Case number: **2020-002853-HDRB**
Project Type: HDRB

PROJECT LOCATION (S): 675 Alto Street

675 Alto Studio

Summary of Proposed Changes

G1.1
16 Site Plan

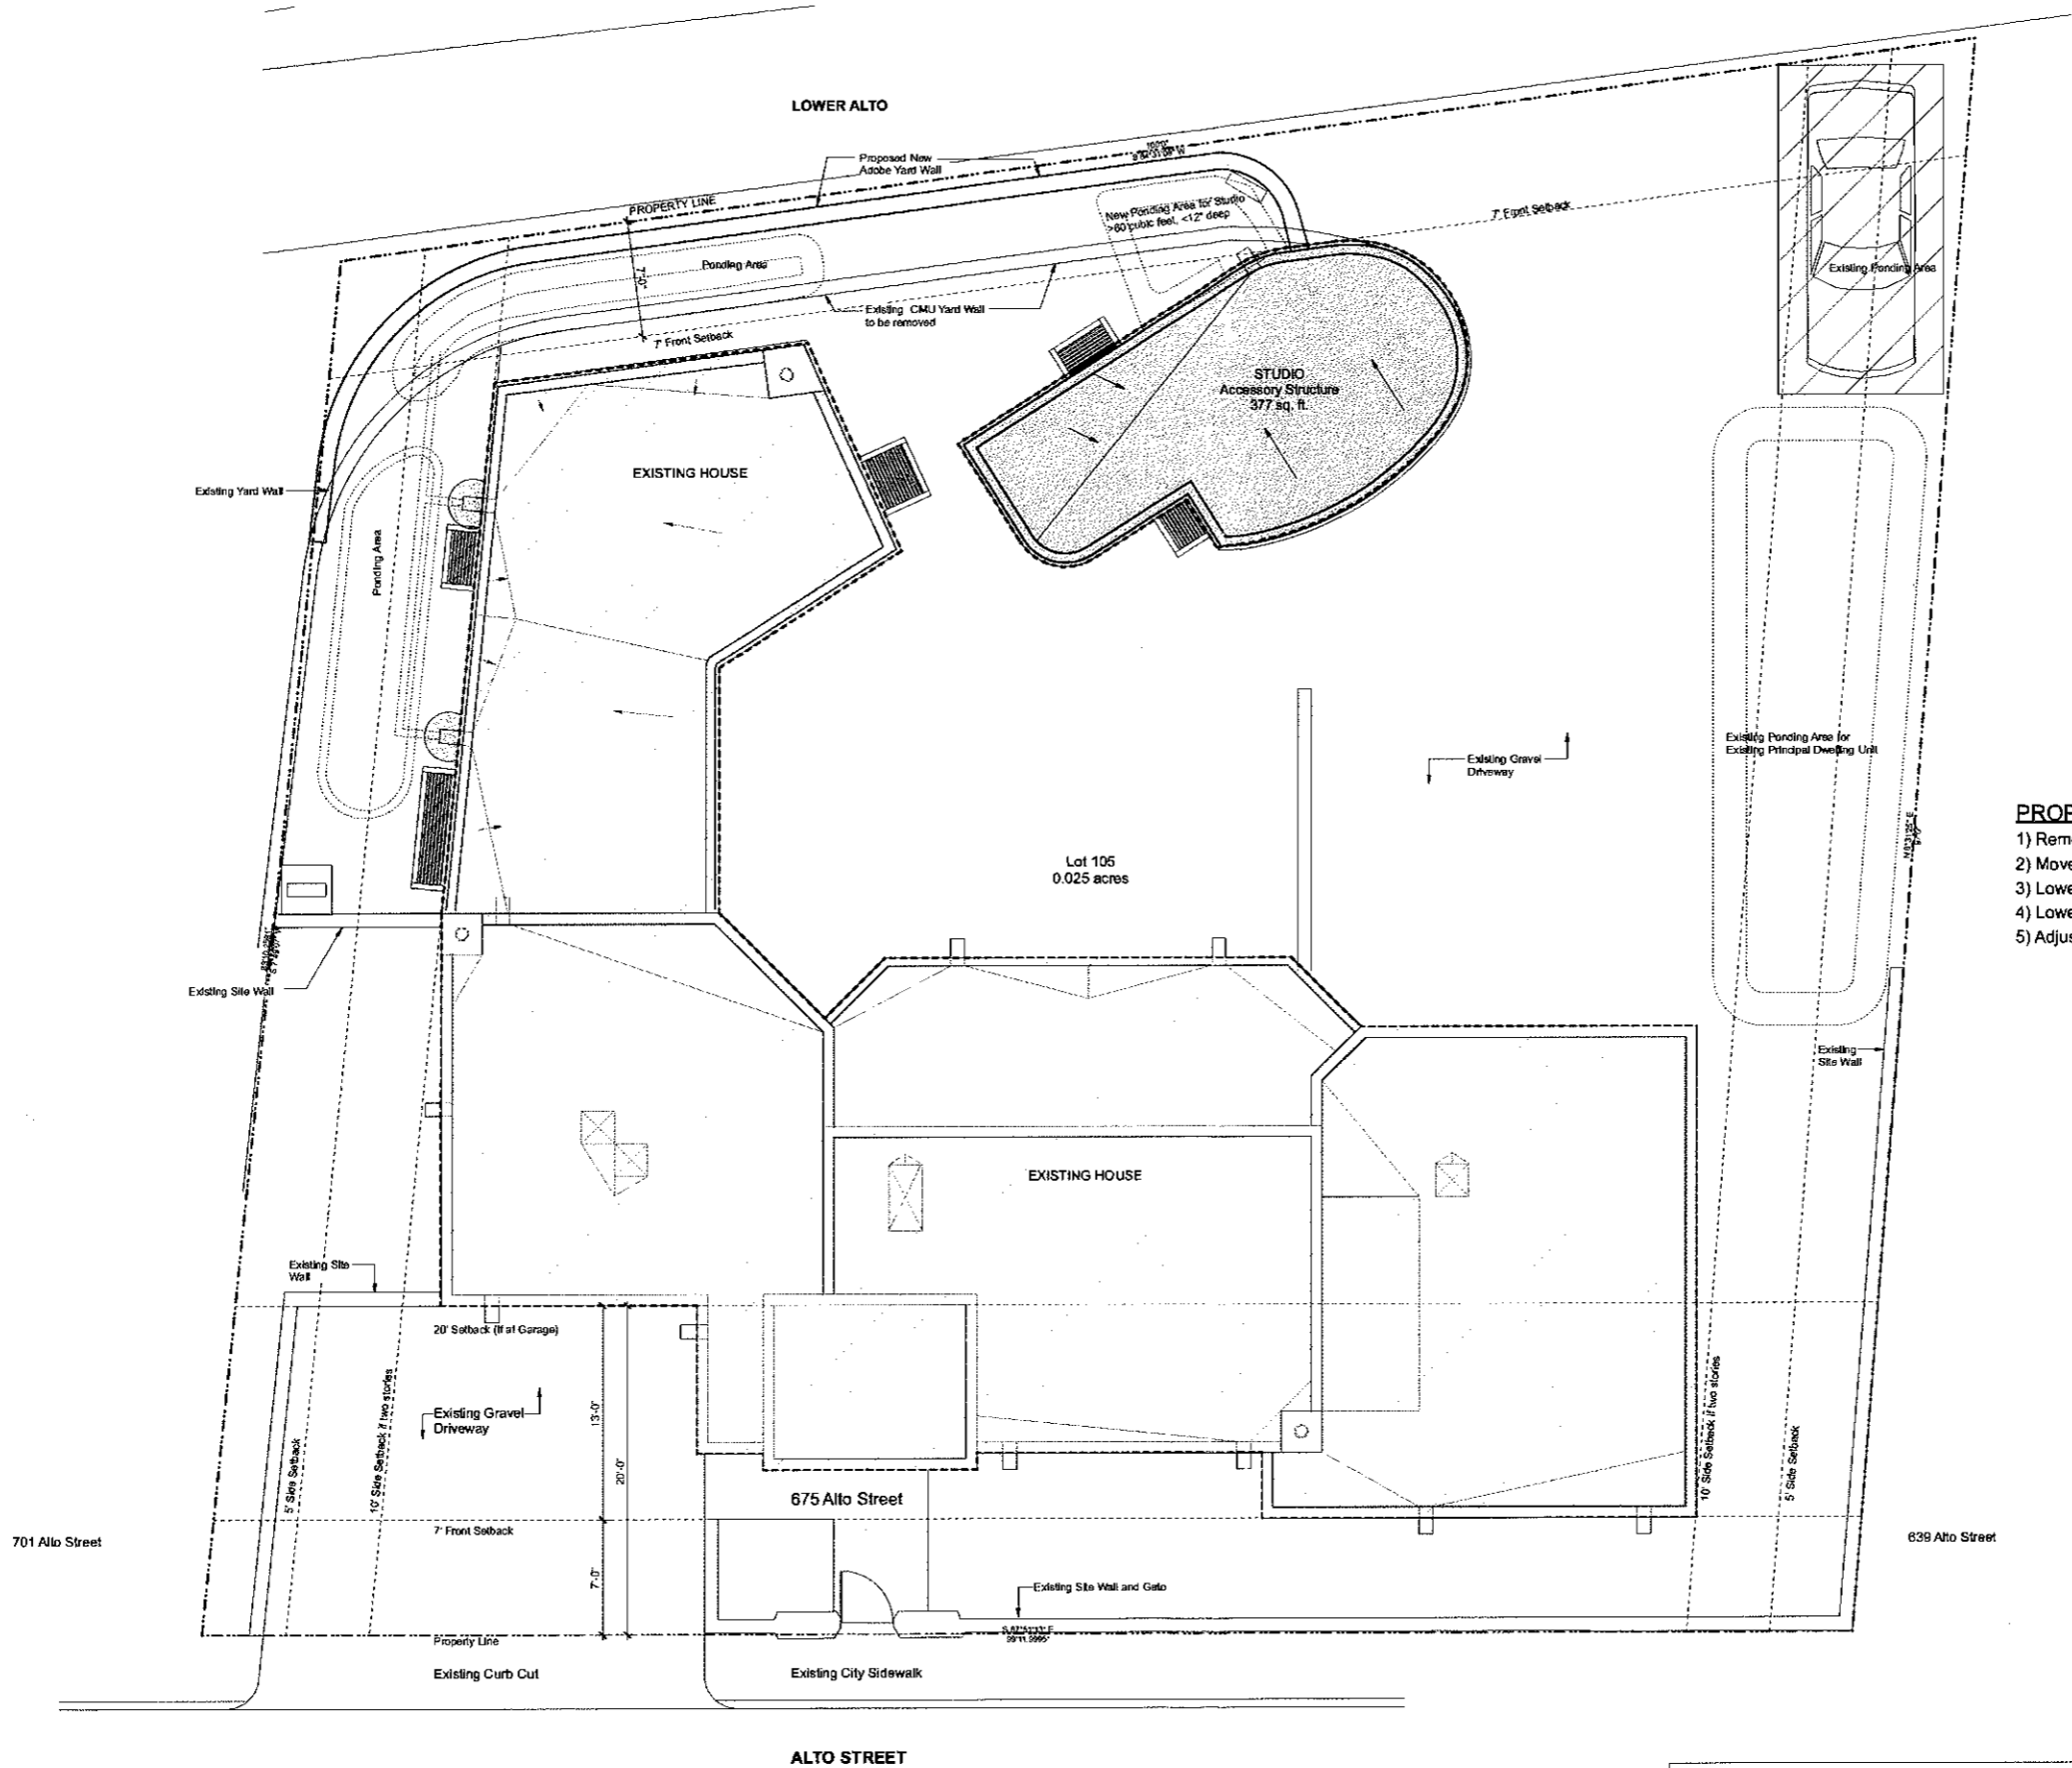
- 1) Remove existing CMU wall and replace with Adobe wall
- 2) Move existing yard wall approximately 6'-0" North inside property line
- 3) Lower yard wall height by 1'-0" to approximately 5' to 6' along lane
- 4) Lower finish floor level $\pm 12"$
- 5) Adjust location of onsite ponding

October 12, 2020
Proposed Revisions
Documents
A1.0
17 Floor Plan

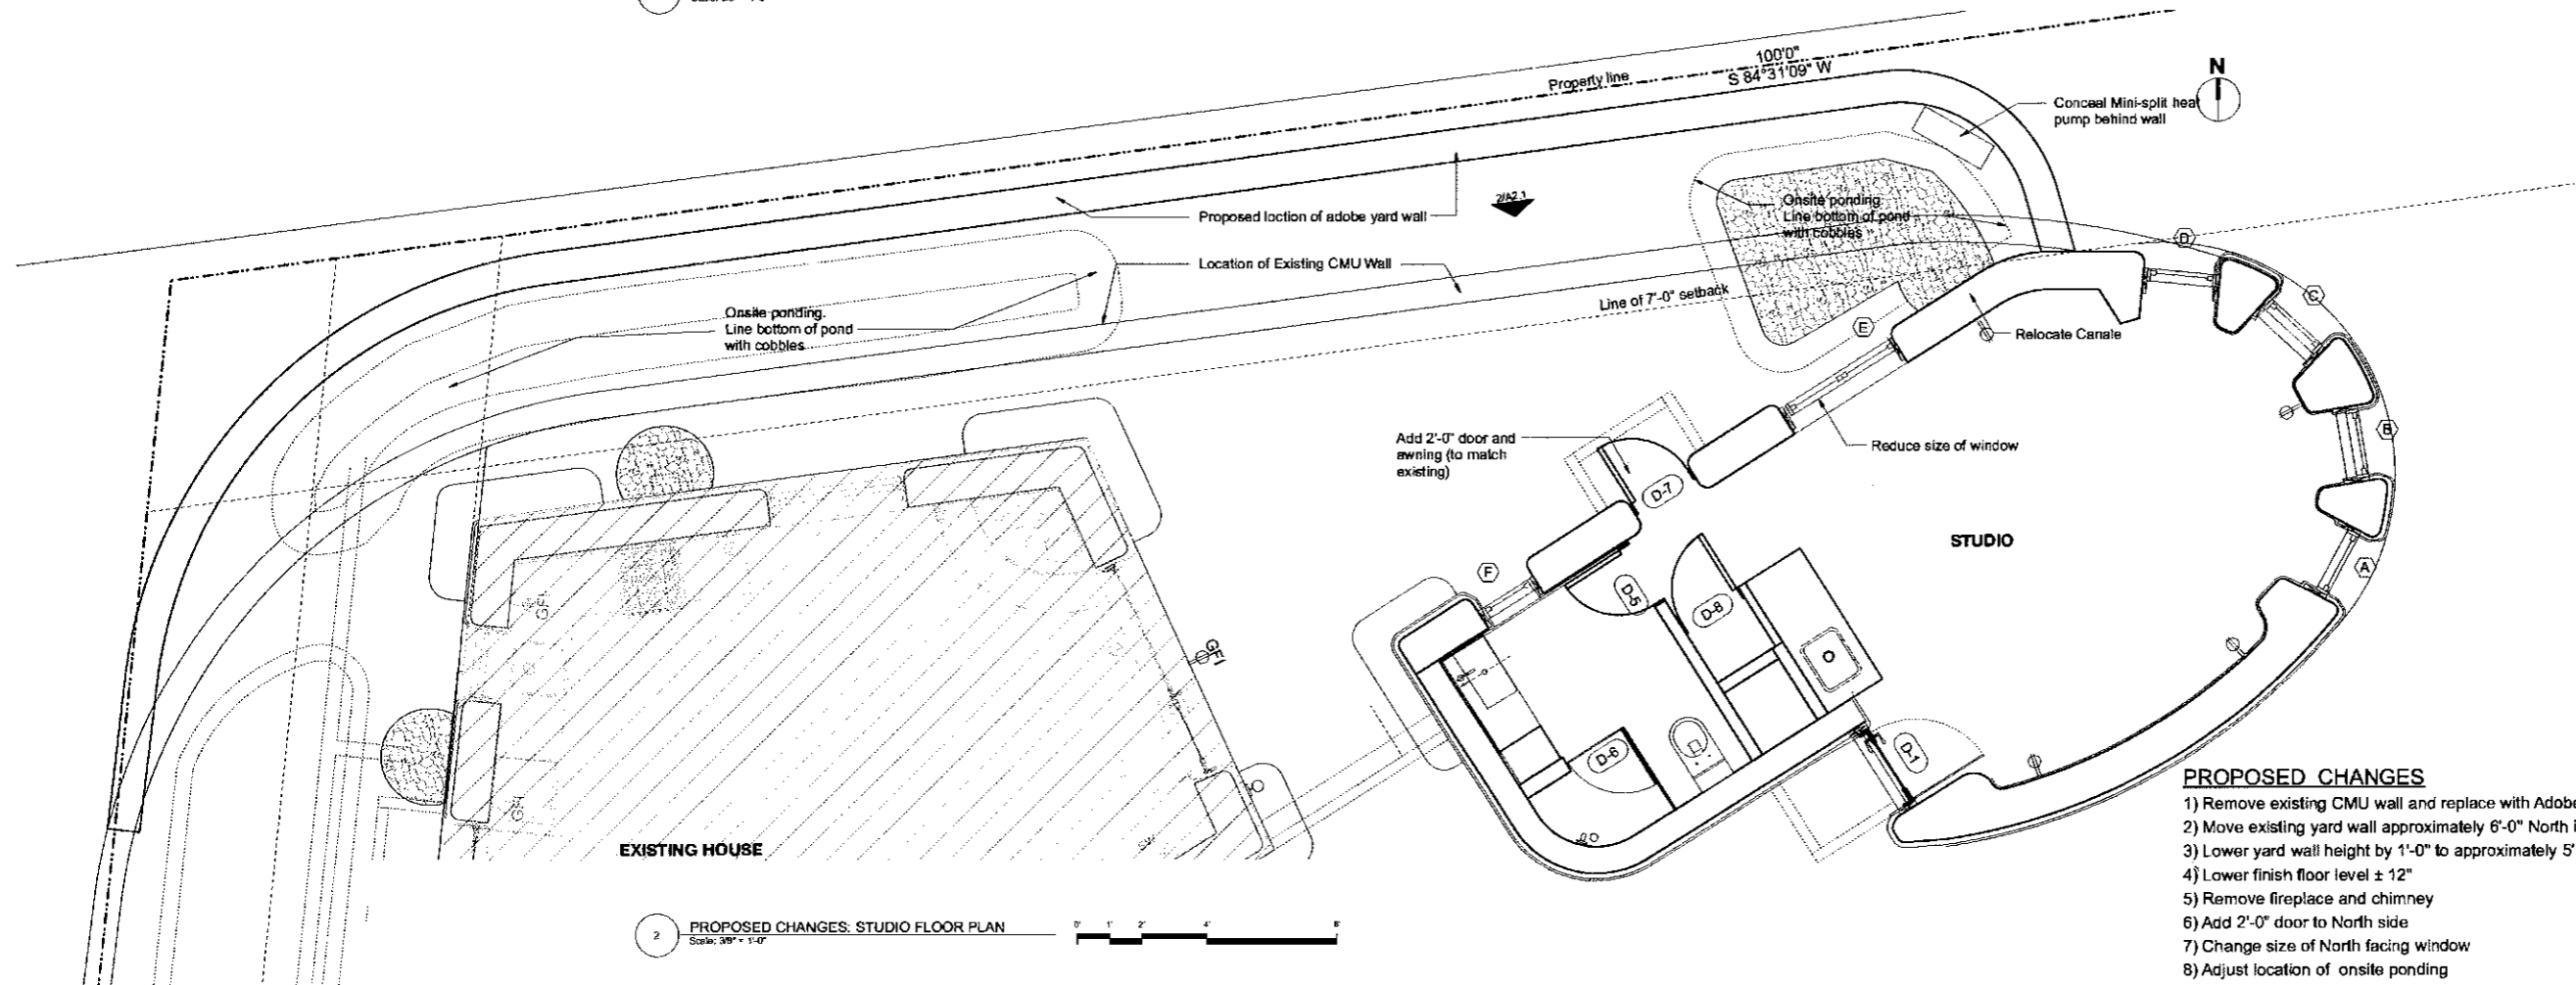
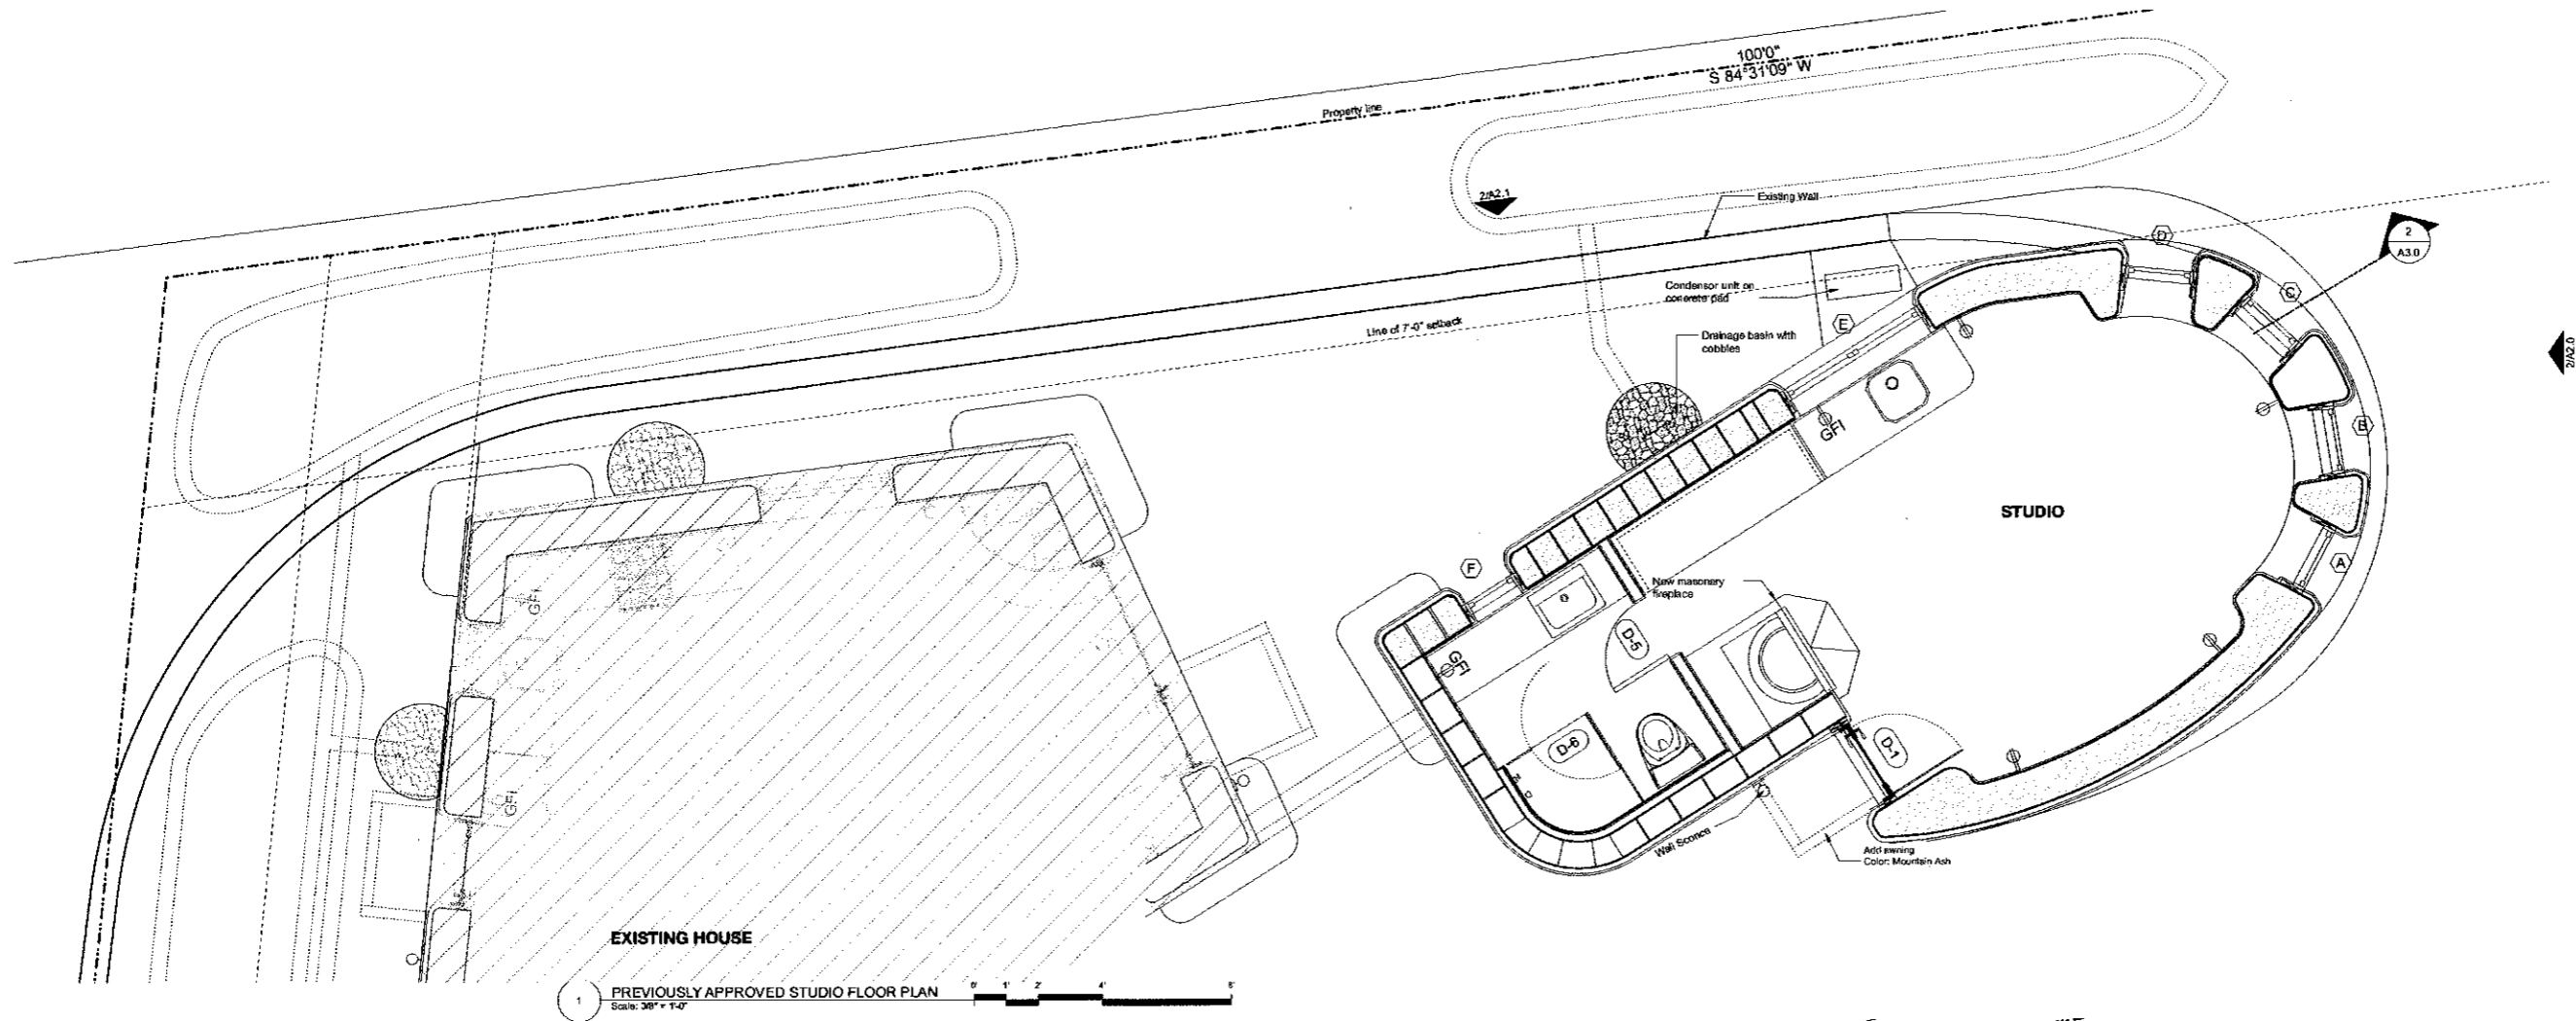
- 1) Remove existing CMU wall and replace with Adobe wall with decorative stone base.
- 2) Move existing yard wall approximately 6'-0" North inside property line
- 3) Lower yard wall height by 1'-0" to approximately 5' to 6' along lane
- 4) Lower finish floor level $\pm 12"$
- 5) Remove fireplace and chimney
- 6) Add 2'-0" door to North side
- 7) Change size of North facing window
- 8) Adjust location of onsite ponding
